Re: Minor Project Refinement No. 15 for the TL 6975 San Marcos to Escondido Project

TL6975 San Marcos to Escondido 69 kV Project CPUC Minor Project Refinement Form

Report No.: 15

ATTACHMENT B
MPR-15 Figure

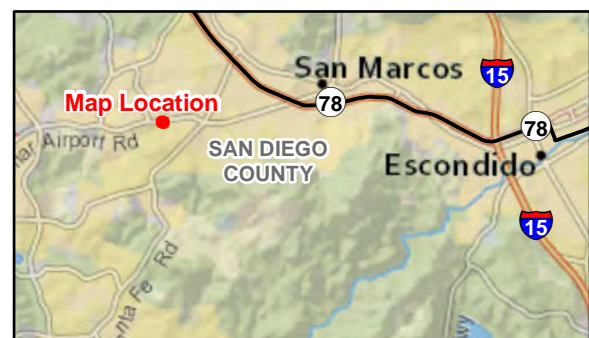
San Diego Gas and Electric (SDG&E) is requesting approval of MPR-15 for the use of a temporary construction access road to be located between San Marcos Boulevard and Location 36 for the TL6975 San Marcos to Escondido Project (Project). See **Attachment B, MPR-15 Figure** and **Attachment C, MPR-15 Site Photographs**, for an overview of the proposed MPR-15 temporary construction access road. It is important to note that use of the MPR-15 access road would eliminate the need for, and use of, the approved permanent access road to Location 36 that was included in the IS/MND, PTC, and NTP-1.

Justification for Change: During negotiations with the City of San Marcos and other landowners adjacent to Location 36 to expand the SDG&E ROW, SDG&E was informed that the approved access road to Location 36 (refer to **Attachment B, MPR-15 Figure**) could not be permanently maintained. SDG&E reviewed the option of constructing a temporary construction access road within the footprint of the approved permanent access road as well as other potential temporary access points, including the proposed MPR-15 temporary access road. SDG&E found that utilization of a more direct access point to Location 36 would require less construction and ground disturbance. SDG&E ultimately selected the MPR-15 road alignment because it was both the shortest distance from San Marcos Boulevard to the structure location and contained the most uniform topography, both of which also limit the amount of construction-related ground disturbance and site preparation.

MPR-15 would result in a net reduction in impact area, including a reduction in permanent impacts. The MPR-15 temporary access road would replace the approved permanent access road (refer to **Attachment B, MPR-15 Figure**). The proposed MPR-15 access road would be approximately 32 feet in length (from San Marcos Boulevard to the boundary of the approved Location 36 work area) and 14 feet wide (448 square feet). Whereas the approved access road is approximately 85 feet long and 12 feet wide (1,020 square feet).

Photograph 1:
View of the existing pole at Location 36 and the approved permanent access road. Facing: Southeast

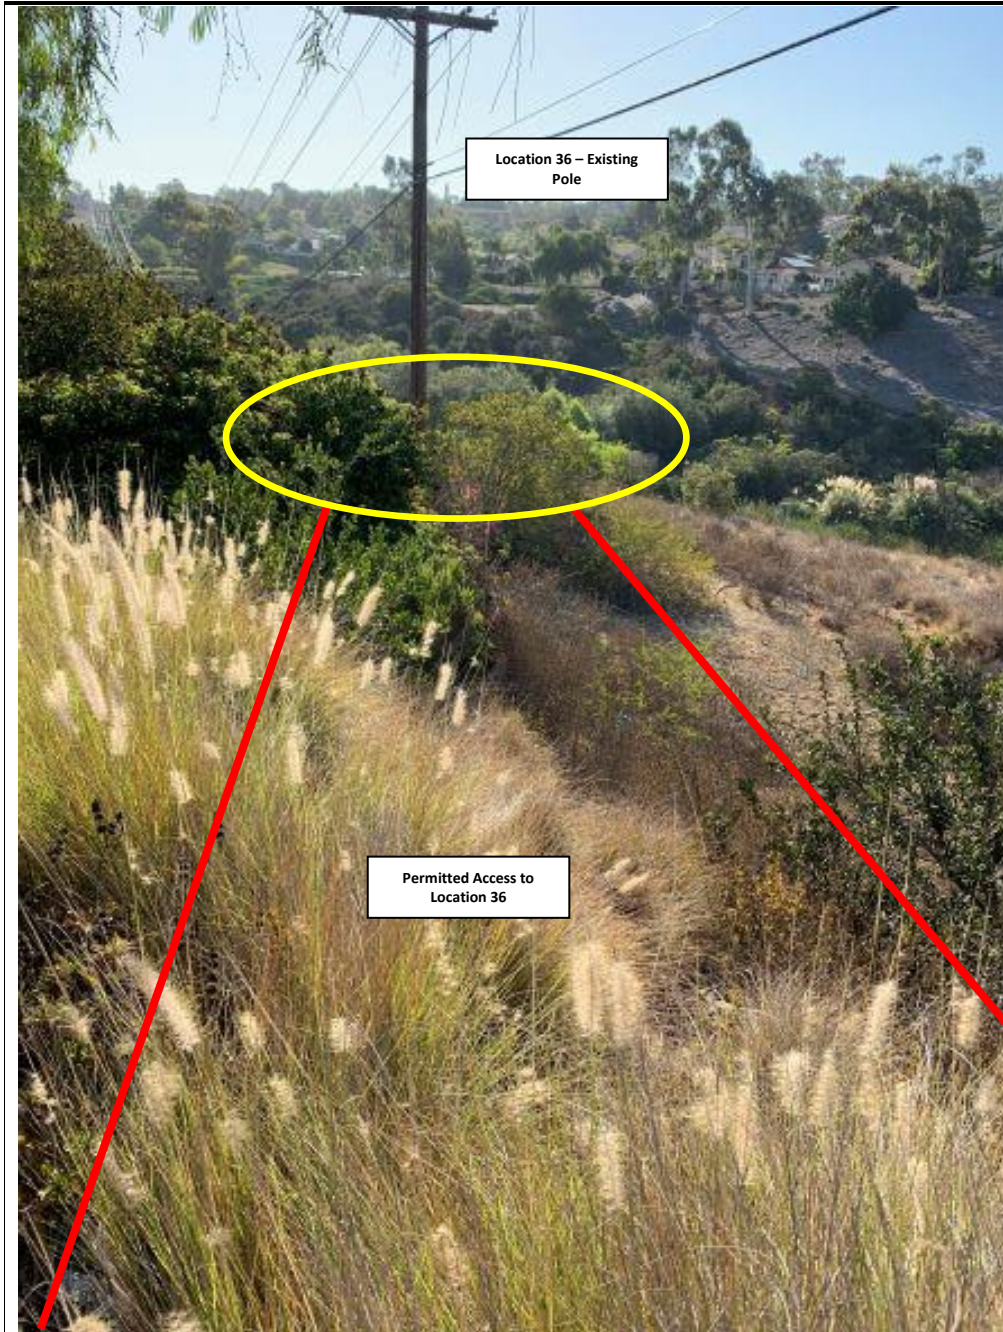
Please see **Attachment C (MPR-15 Photographs)** to see photographs of the existing conditions of the proposed and originally approved access roads. The temporary disturbance associated with the MPR-15 temporary access road will be stabilized in accordance with the Project SWPPP or otherwise restored in coordination with the property owner pursuant to the requirements of the SDG&E Subregional NCCP.

Maps & Figure: Refer to **Attachment B, MPR-15 Figure**, for a map of the proposed MPR-15 access road. Refer to **Attachment C, MPR-15 Site Photographs**, for pictures of the current conditions of the MPR-15 access road as well as the originally approved permanent access road.
